The KOREA-Comment on proposed amendments to GTR 6 by OICA/CLEPA

24. Feb. 2016

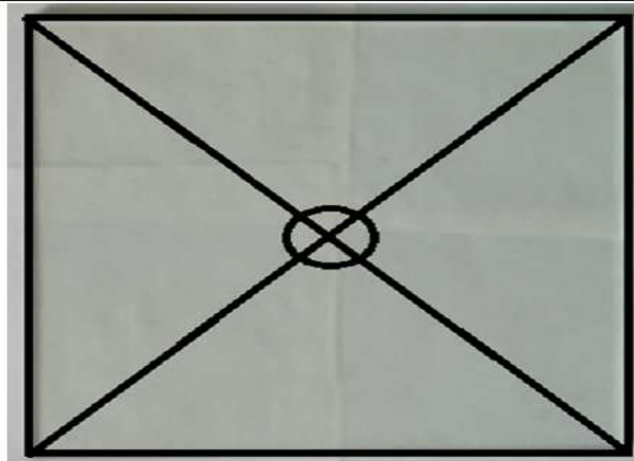
- The OICA/CLEPA proposals is to aim amendment about 227g ball drop test same as ISO 3537/UN Reg No. 43

"6.3.2.3. The point of impact shall be within 25 mm of the **geometric centre of the test piece supported area** for a drop height less than or equal to 6 m, and within 50 mm of the centre of the **supported area test piece** for a drop height greater than 6 m."

- Simple comparison table of 227g ball test on toughened glass

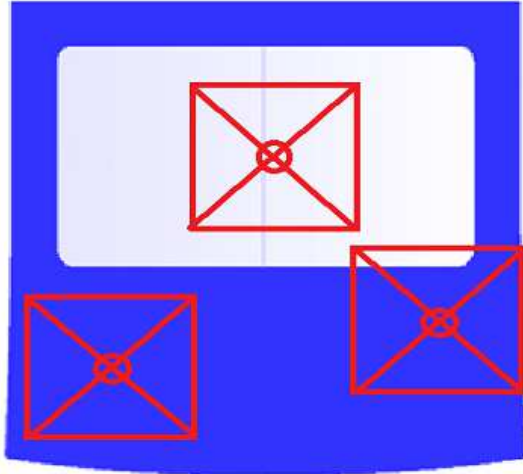
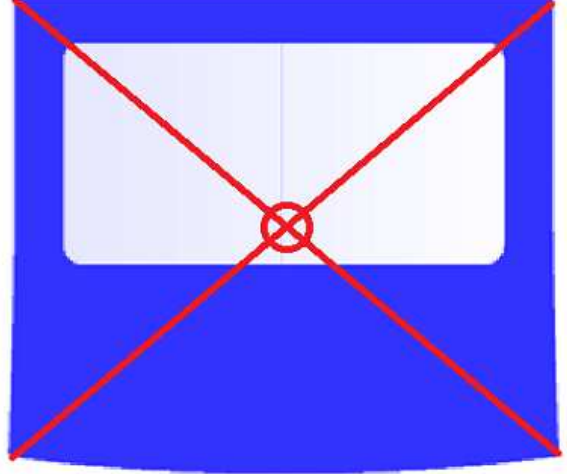
- The KOREA position :

- The KOREA position(2) :
 - Simple comparison of 227g ball test procedure on toughened glass
 - In case of Flat 300 x 300 mm sample :
 - Completely Same as the impact point both the center of supported area and the geometric centre of test piece

- The KOREA position(3) :
 - Simple comparison of 227g ball test procedure on toughened glass
 - In case of finished products :
 - To be possible to be different impact point between the center of supported area and the geometric centre of test piece
